APPLICATION FOR A RESIDENTIAL SITE IMPROVEMENT PERMIT/ CONSTRUCTION AUTHORIZATION FOR AN ON-SITE WASTEWATER SYSTEM, NEW WELL INSTALLATION, OR REPAIR OF EXISTING WELL

IMPROVEMENT PERMIT for a RESIDENTIAL ON-SITE WASTEWATER TREATMENT & DISPOSAL SYSTEM

Soil and Onsite Wastewater Investigation Map- 17837 New Mark Avenue, PIN# 217-172-06, Lake Wylie (Meck. Co.), NC. (MSI (Sept. 2017))

Re: 17837 New Mark Avenue – Drainfield Distribution (PIN# 217-172-06)

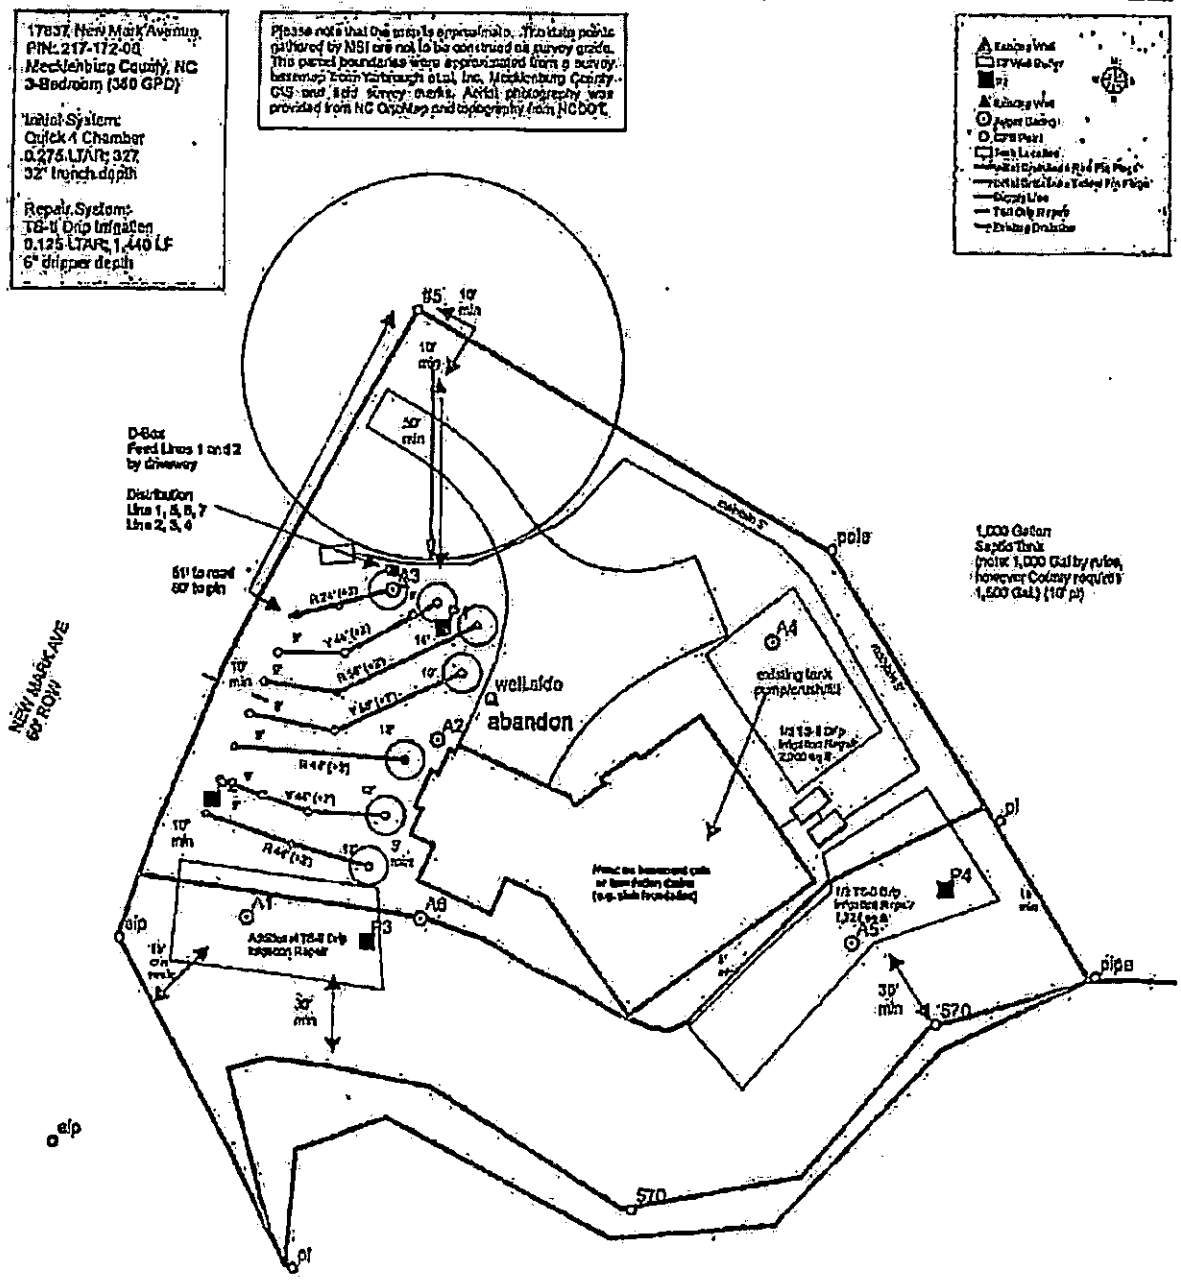
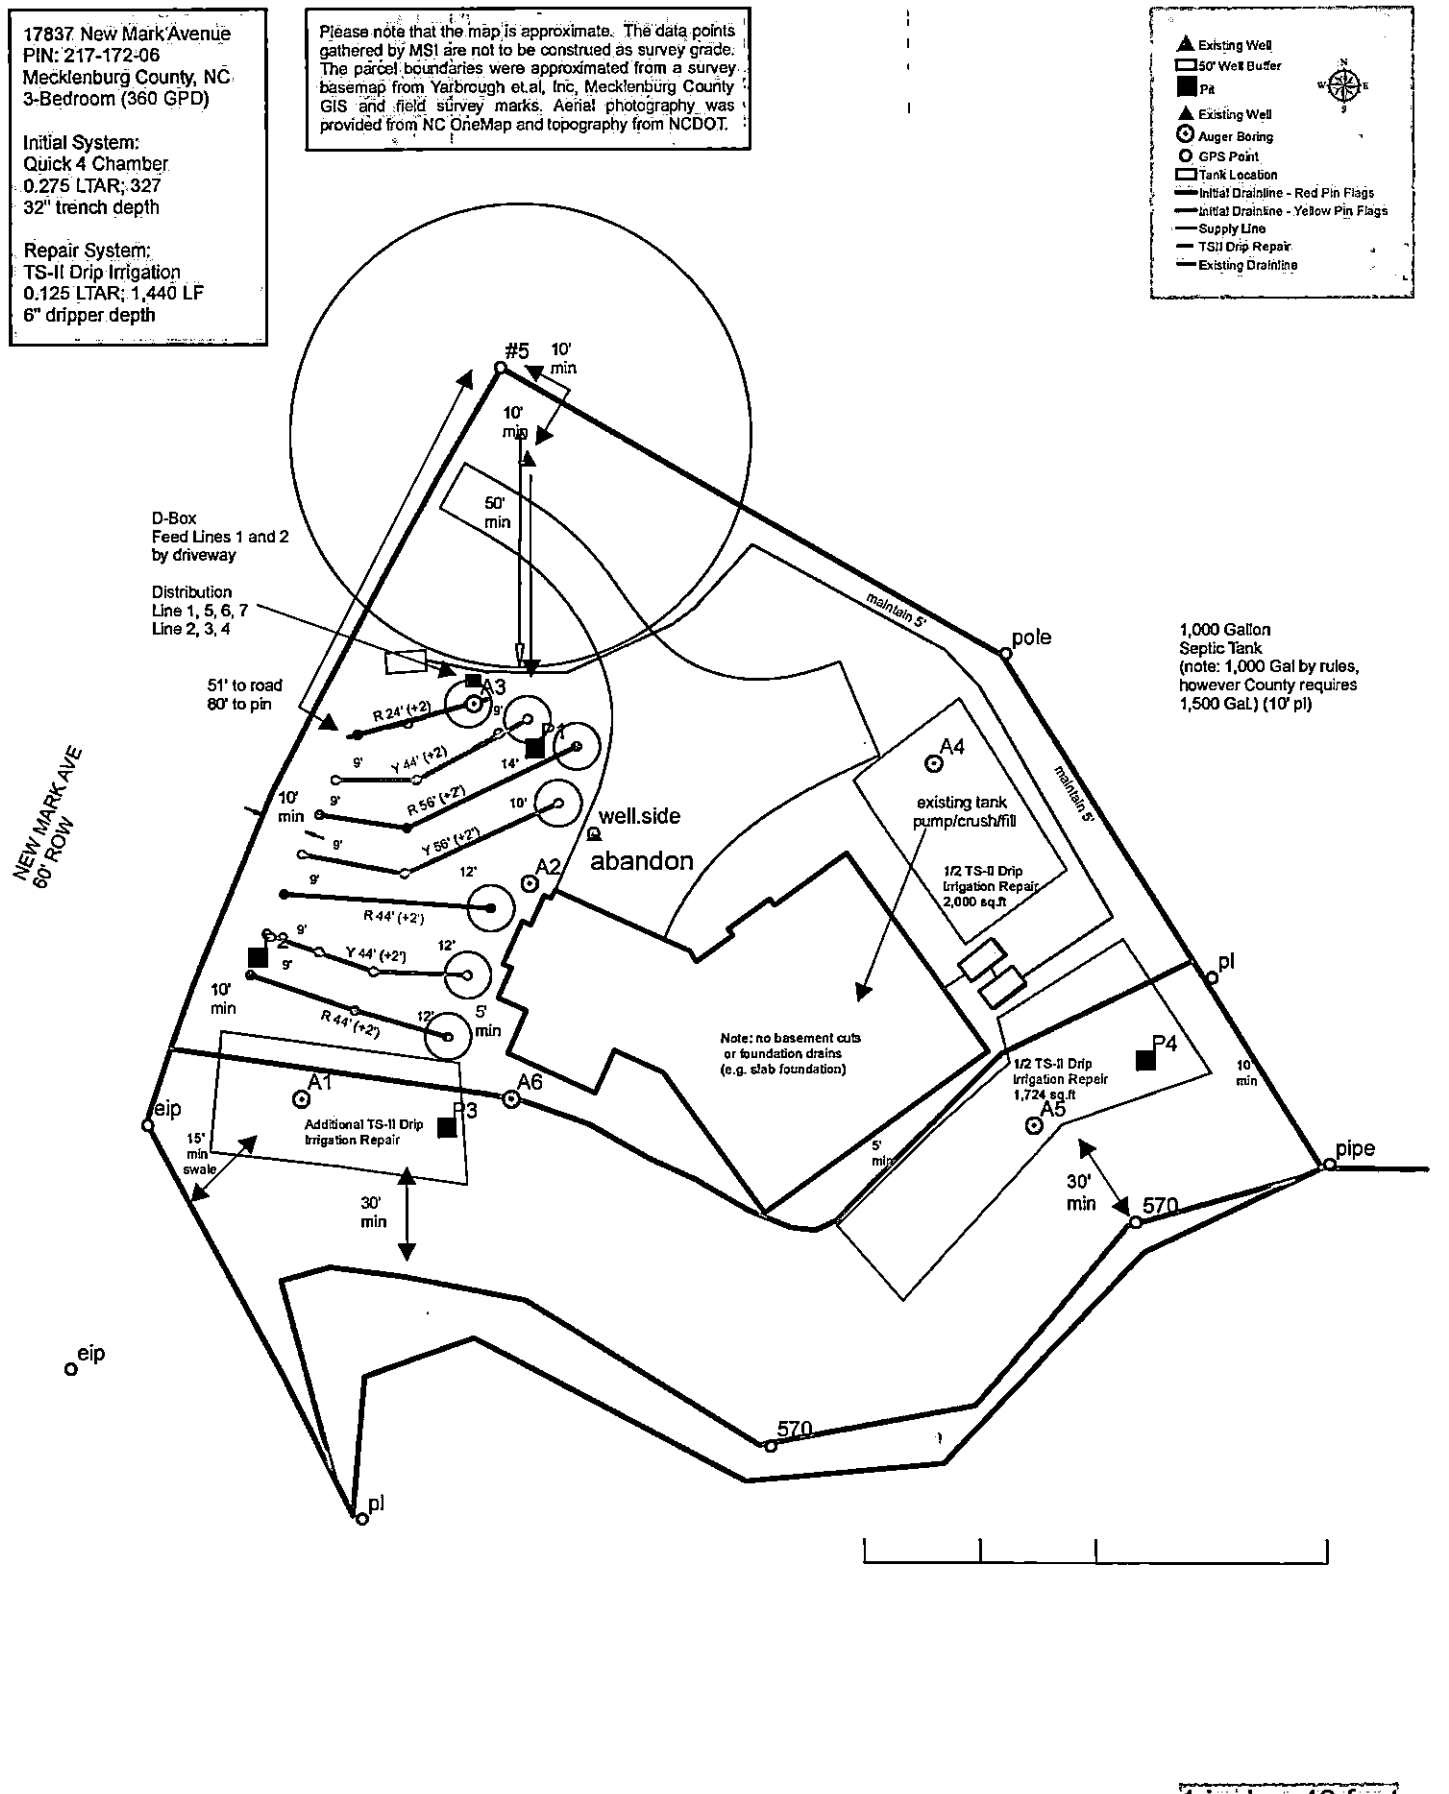
Initial System:
Quick 4 Chamber
0.275 LTAR; 327
32" trench depth

Repair System:
TS-II Drip Irrigation
0.125 LTAR; 1,440 LF
6" dripper depth

Soil and Onsite Wastewater Investigation Map- 17837 New Mark Avenue, PIN# 217-172-06. Lake Wylie (Meck. Co.), NC. (MSI (Sept. 2017))

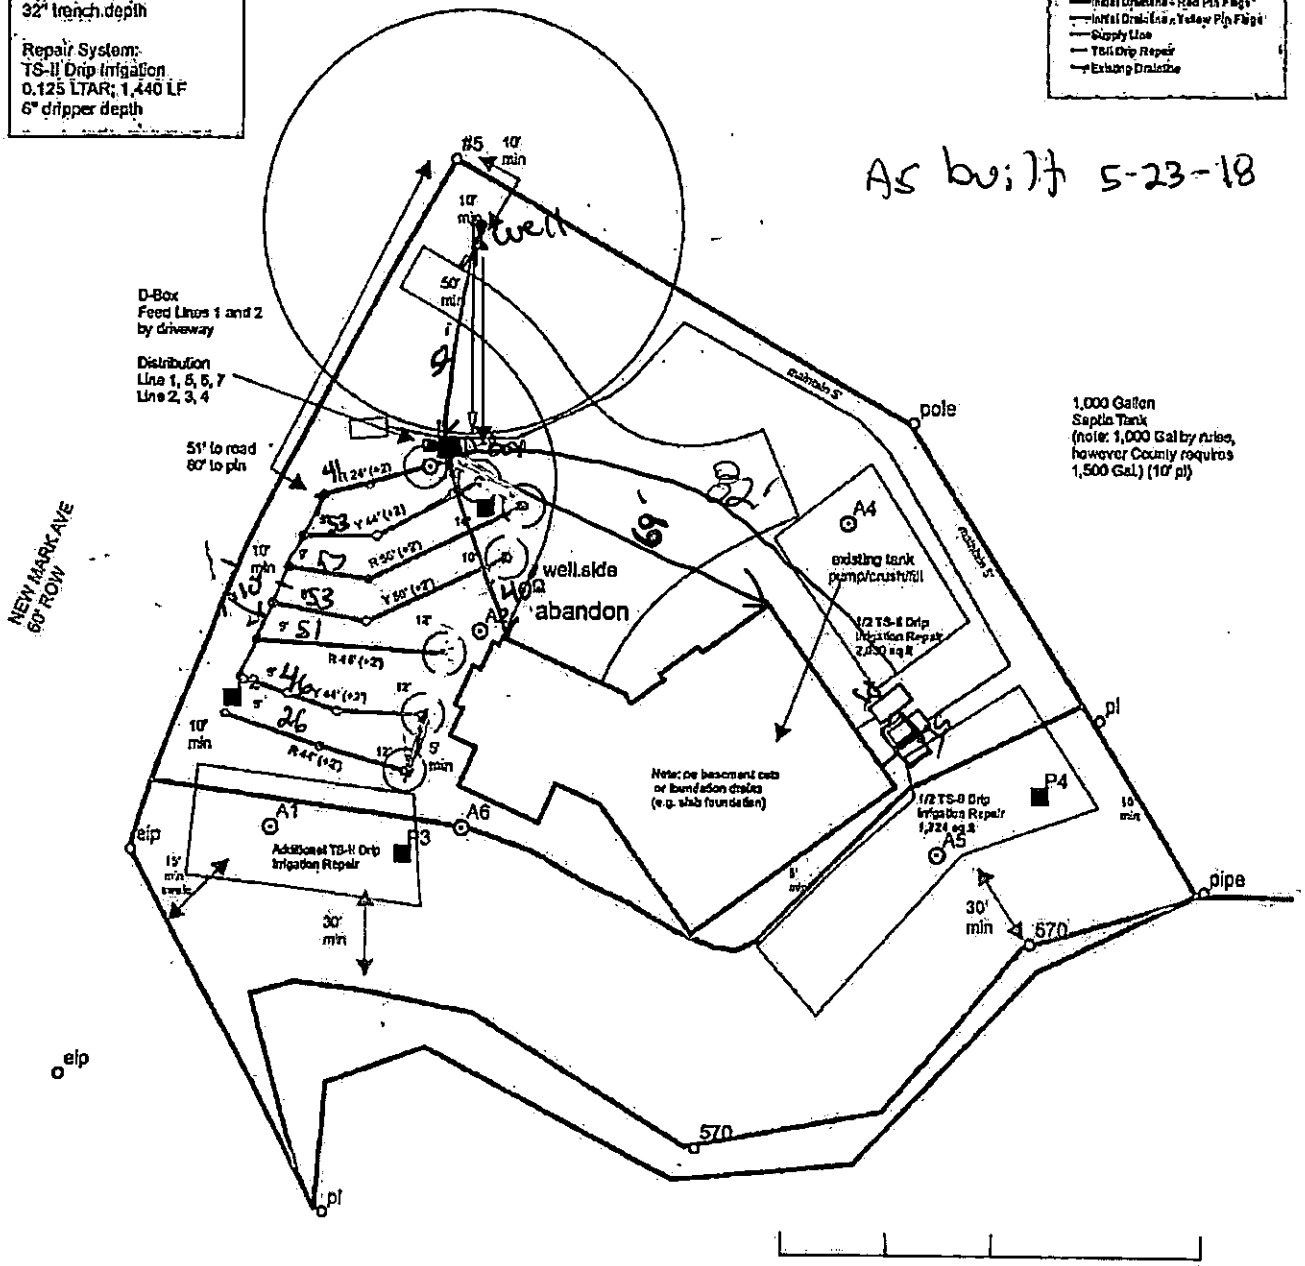
> ***System type has been modified by design consultant from PPBPS to an Accepted System (25%) reduction***
